Approval for bungalow and septic tank at Redgap,
Rathcoole for S. and P. Ryan.

Reg. Ref. 91A-0667
Appl. Rec'd: 25.04.1991
Floor Area: 166 m²
Site Area: 2,840 sq. m.
Zoning:

Report of the Dublin Planning Officer, dated 18 September 1991

DETAILS OF CONCRETE BLOCK SEPTIC TANK.

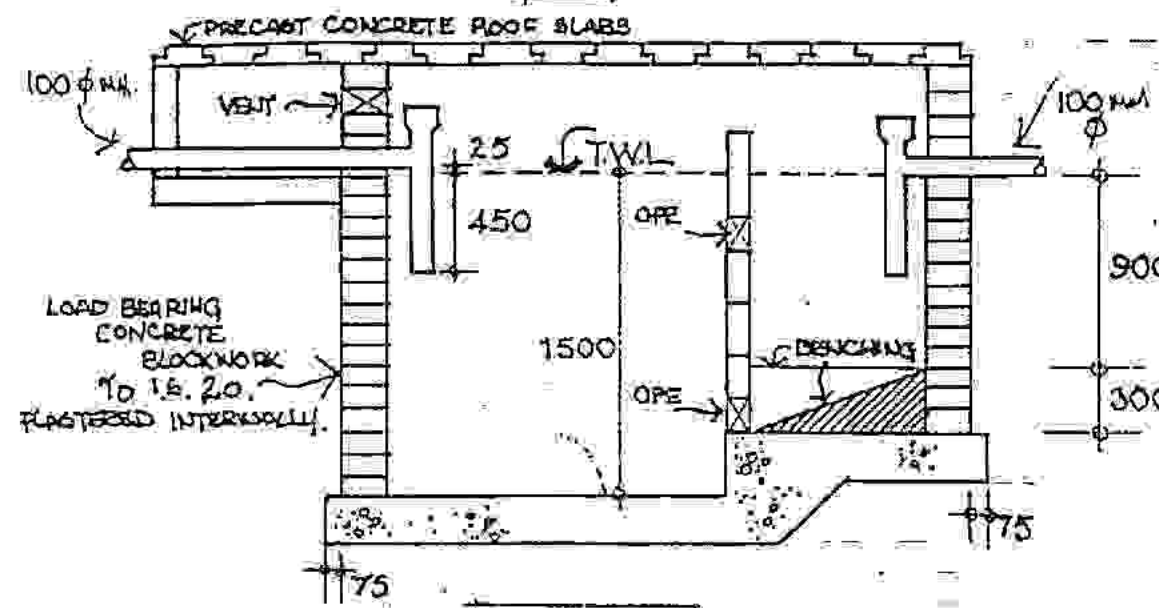
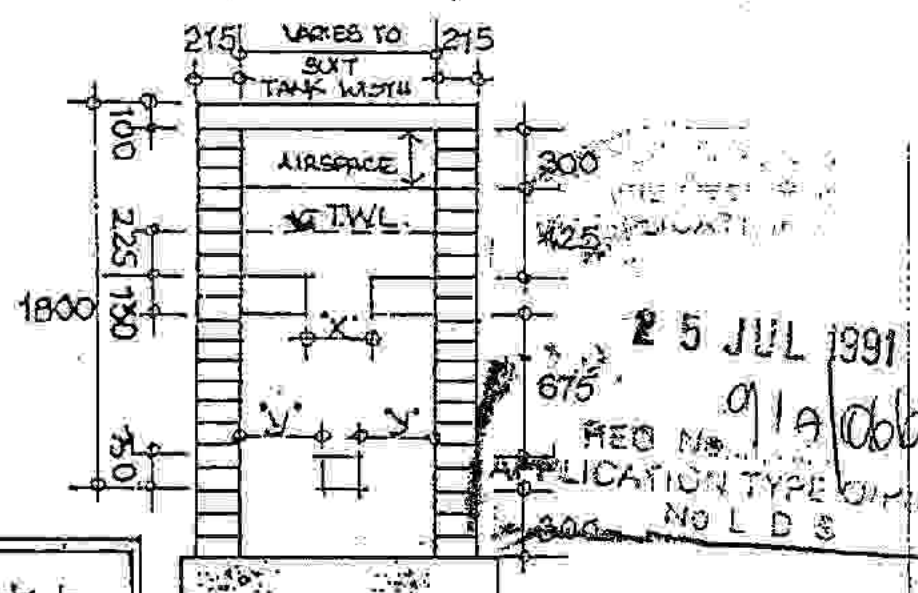
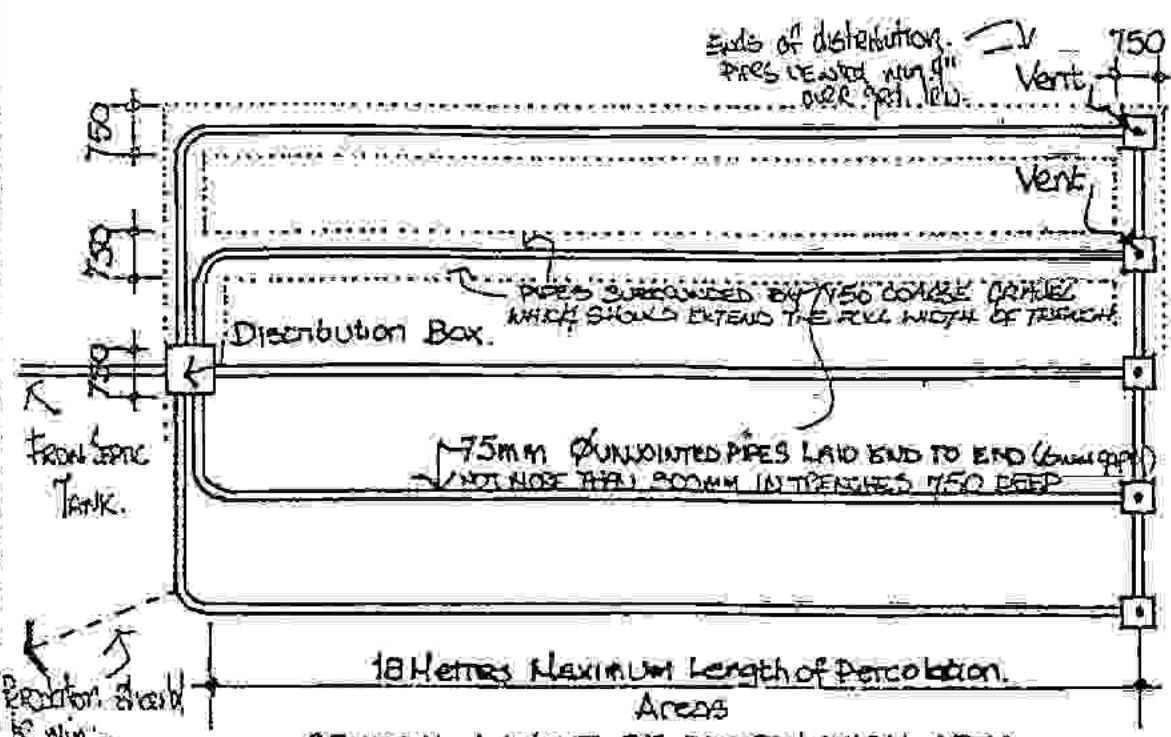
1. Evidence of soil suitability for septic tank drainage not submitted.
2. Percolation area too close to proposed dwelling.
3. Location of bored well or other water source not ideal & evidence of water stability and adequacy of supply.
4. Plan of septic tank not included.
5. Percolation pipe indicated as going against the contours ~~to the well~~.

6. Location of existing wells and percolation areas for adjoining dwellings H. Waller.

We enclose Revised Drawgs. as requested by your
letter 13th June '91
